UNITED STATES PATENT AND TRADEMARK OFFICE

10/814,945

Office Action Summary

DETAILED ACTION

Figure 2 from Harper

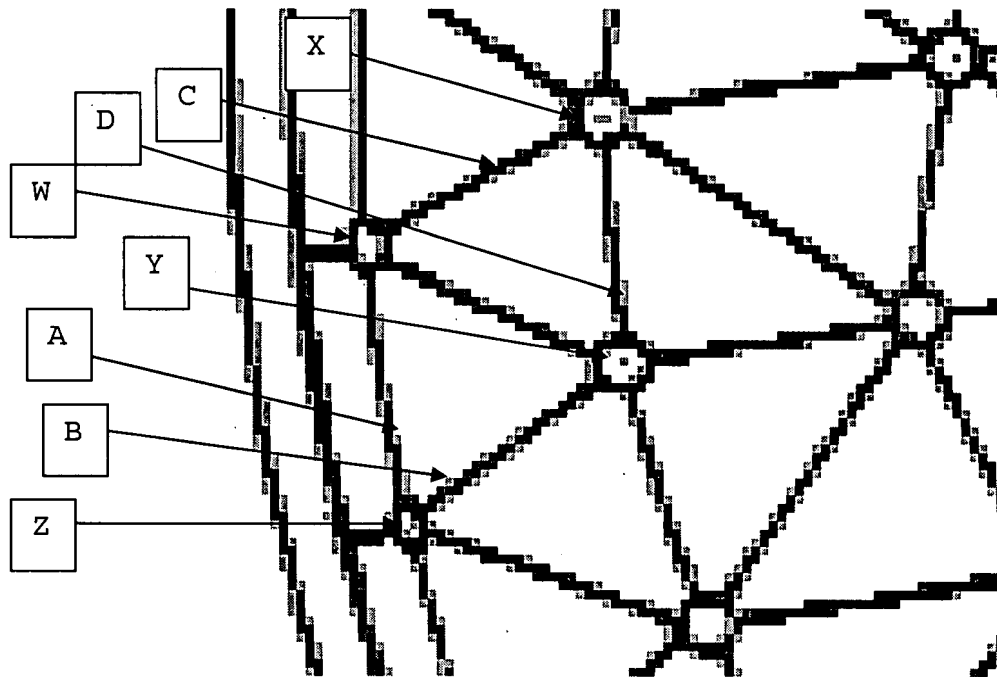
Independent Claim 11: Harper discloses a work platform support system having a plurality of joists (14) and a plurality of hubs (12) the joists have four joists ("A", "B", "C" and "D", respectively from attached Figure 2 from Harper below) and four hubs ("W", "X", "Y" and "Z", respectively below), one joists and two hubs are stationary ("A", "W" and "Z") and two of the joists are rotatable ("B" and "C"; the joists are rotatable in that they have the capability to rotate) and two hubs and one joist

("X", "Y" and "D") are translatable (the hubs and joist are translatable in that they are capable of translation) and the two rotatable joists, translatable hubs and translatable joist can articulate with respect to the stationary joist and stationary hub so as to receive a work platform (26). Applicant should also respectfully note that claims drawn to "translation", "rotation", "pivoting" and "articulation" are met by the prior art of record in that while the joists are attached to the hubs, the resulting connection permits translation, rotation, pivoting and articulation, no matter how minimal.

Claim 23: Harper discloses four hubs ("W"- "Z" above) and four joist mechanisms ("A"- "D" above) interconnected with the hubs, one joist ("A") and two hubs ("W", "Z") are stationary,

two joists are rotatable ("B", "C"), two hubs and one joist are translatable ("X", "Y", "D") and the mechanism can articulate with respect to the stationary joist mechanism to receive a work platform (26). The phrase "can articulate...a work platform" line 14, is a statement of intended use of the claimed invention and must result in a structural difference between the claimed invention and the prior art in order to patentably distinguish the claimed invention from the prior art. If the prior art structure is capable of performing the intended use, then it meets the claim.

Claim 24: Harper discloses a plurality of joists ("A"- "D") and a plurality of hubs ("W"- "Z"), a suspension connector (300) for suspending the hub, one joist ("A") and two hubs ("W", "Z") are stationary, two joists are rotatable ("B", "C"), two hubs and one joist are translatable ("X", "Y", "D") and the mechanism can articulate with respect to the stationary joist mechanism to receive a work platform (26). The phrase "can articulate...a work platform" line 14, is a statement of intended use of the claimed invention and must result in a structural difference between the claimed invention and the prior art in order to patentably distinguish the claimed invention from the prior art. If the

Claim 26: Harper discloses a platform by providing four joists ("A"- "D") and four hubs ("W"- "Z") the hubs are pivotally attached (see rejection of Claim 1 above for explanation of terms such as "pivotally") to the joists such that one of the joists ("A") and two hubs ("W", "Z") are stationary, two joists ("B", "C") are rotatable, and two hubs and one joist ("X", "Y", "D") are translatable and there is articulation among the elements so as to receive a work platform (26).

Claim 30: Harper discloses a work platform structure having first and second hubs ("W", "Z") connected by a first joist ("A"), a third hub ("X") connected to a fourth hub ("Y") using a second joist ("D") the third and fourth hubs are connected to the first and second hubs with third and fourth joists ("B", "C") there is articulation to receive a work platform (see rejection of claim 1, above for explanation).

Figure 4 from Harper

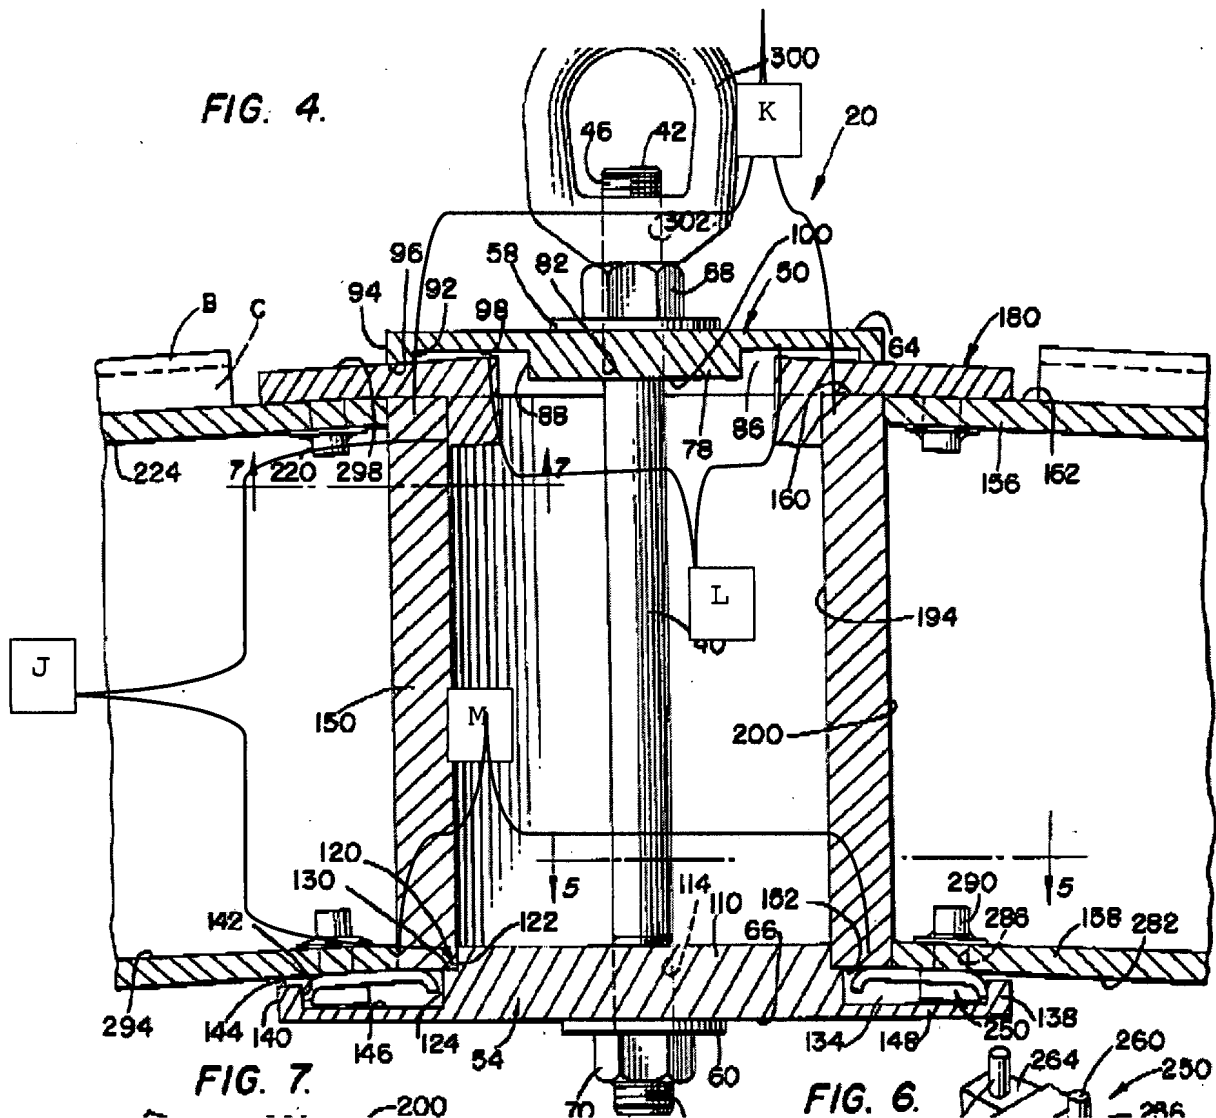
Claim 7: the hubs have a plurality of openings to receive the joists (see "J" and "K" from attached Figure 4 from Harper below.)

Claim 13: at least one hub has a first set of openings (114, "M" from attached Figure 4, above), a second surface parallel to the first surface having a second set of openings

(proximate "K", "L" above) a structural element (150) interspersed between the first and second surfaces. The phrase "adapted to provide an articulation...at least one joist", lines 7 and 8, is a statement of intended use of the claimed invention and must result in a structural difference between the claimed invention and the prior art in order to patentably distinguish the claimed invention from the prior art. If the prior art structure is capable of performing the intended use, then it meets the claim.
